TITLE:	Software update for AD32 RVSM Air Data Display					
DOCUMENT NUMBER:	SB AD32/03					
EQUIPMENT:	AD32 RVSM Air Data Display					
© Copyright by THOMMEN AIRCRAFT EQUIPMENT AG, CH-4132 Muttenz, Switzerland

Service Bulletin

SERVICE BULLETIN

Figure 1 - TSO Nameplate

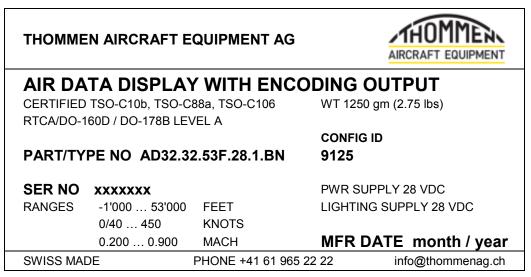
The AD32 RVSM Air Data Display identification plates are attached to the instrument case externally (see Figures 1 and 2). The MOD columns identify the modification status.

The TSO nameplate identifies the LRU by part number and config ID number.

Update the software to version 2.50 and the configuration ID to 9125.

Attach two new identification plates (with THOMMEN AIRCRAFT EQUIPMENT AG name and logo).
